STAFF'S
REQUEST ANALYSIS
AND
RECOMMENDATION

06PR0226

Duke Management Services, Inc.
(Bailey's Bridge Storage)

REQUEST: Site plan approval including approval of a seventy-five (75) foot reduction to a 100 foot buffer requirement.

A101

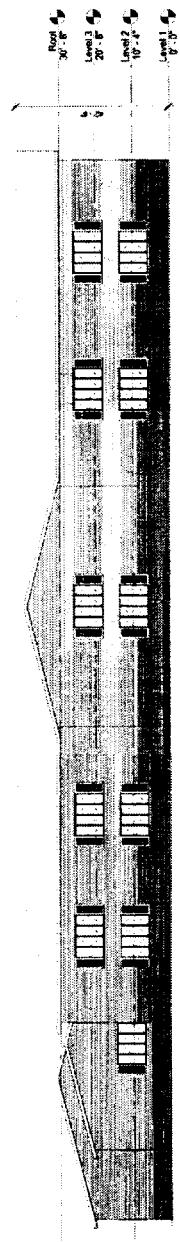
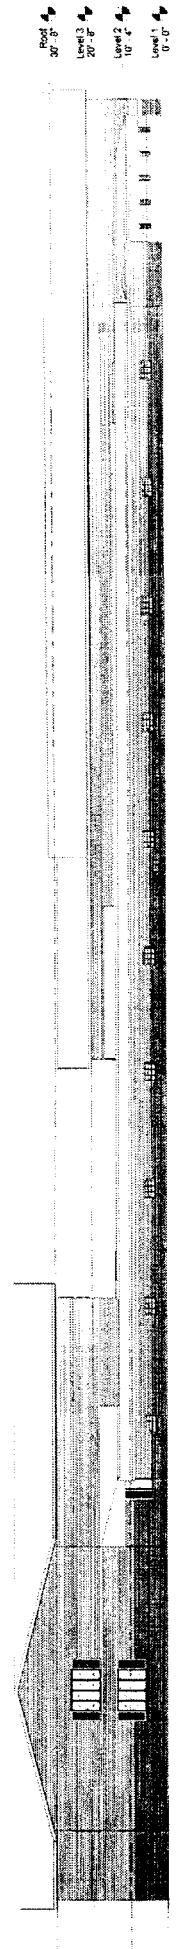
1. The architectural elevations submitted are incomplete as follows:
 - a. No labels are provided indicating the proposed materials and colors. Oversized color renderings were submitted, but do not indicate proposed colors and materials. This information is needed for staff to evaluate compatibility with existing buildings per Sec. 19-570, and compatibility with residential development per Section 19-586(b).
 - b. The elevations of buildings C and D are shown as one continuous building, rather than the two separate buildings indicated on the site plan.
 - c. The architectural treatment of the buildings adjacent to the residential neighborhood employ features that are not consistent with typical residential-scale design features, as required by Sec 19-586(b). For example:

- i. The overall window size on the two and three story buildings is approximately eleven (11) feet wide and seven (7) feet tall, with three (3) by seven (7) foot shutters. The size of these windows and shutters is not consistent with residential-scale design. These windows may be appropriate for portions of the

- ii. Windows indicated on the one-story buildings (buildings C, D, and E) are approximately five (5) feet wide by three (3) feet tall. While the scale of these windows is in keeping with residential design, a vertical orientation (three (3) feet wide by five (5) feet tall) and the addition of shutters would be more consistent with residential construction.

2. In order to minimize the impact of the requested buffer reduction, the north elevations of buildings B, C, and D should be revised to incorporate appropriate residential-scale design features, and to break up the long linear aspect of the walls of buildings D and C.
